# ENA NATIONAL GUIDELINE FOR STANDALONE POWER SYSTEM DRAFT - CEC COMMENTS

## Comments provided by:

The following comments have been made on some of the sections of the guideline and not all sections as specified below.

Figure 1: Example SAPS Configurations: (a) AC coupled and (b) DC coupled systems

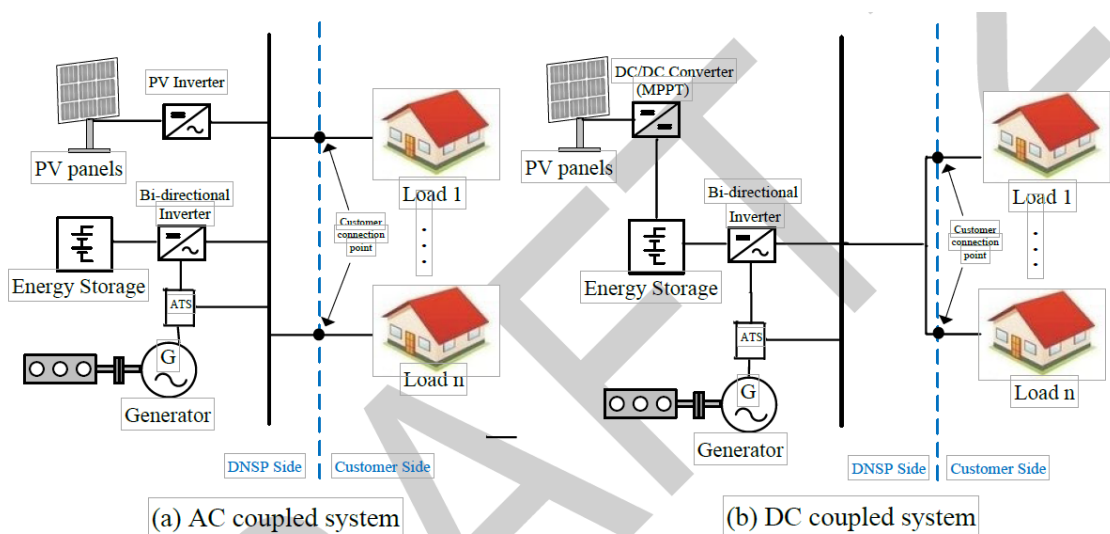
Configuration Diagrams – Industry standard configuration. Micro grid configurations may differ
